NABCO ENTRANCES TECHNICAL BULLETIN

Date: August 18, 2010

New Carrier Roller Design for GT1175 Sliding Doors

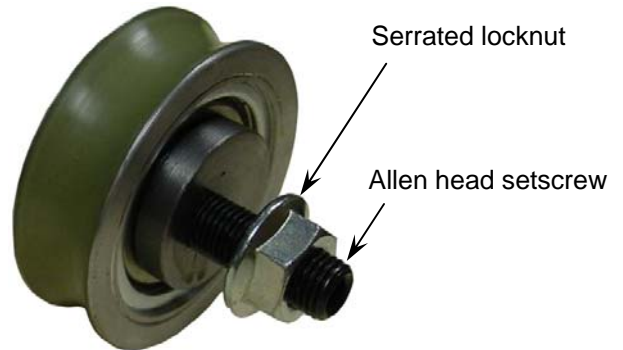
The hex head bolt, lock washer and nut on the old style roller have been replaced with an Allen head setscrew and serrated locknut as shown below.

To adjust the new rollers the following tools are required:

7/32" Allen wrench

11/16" Box end wrench
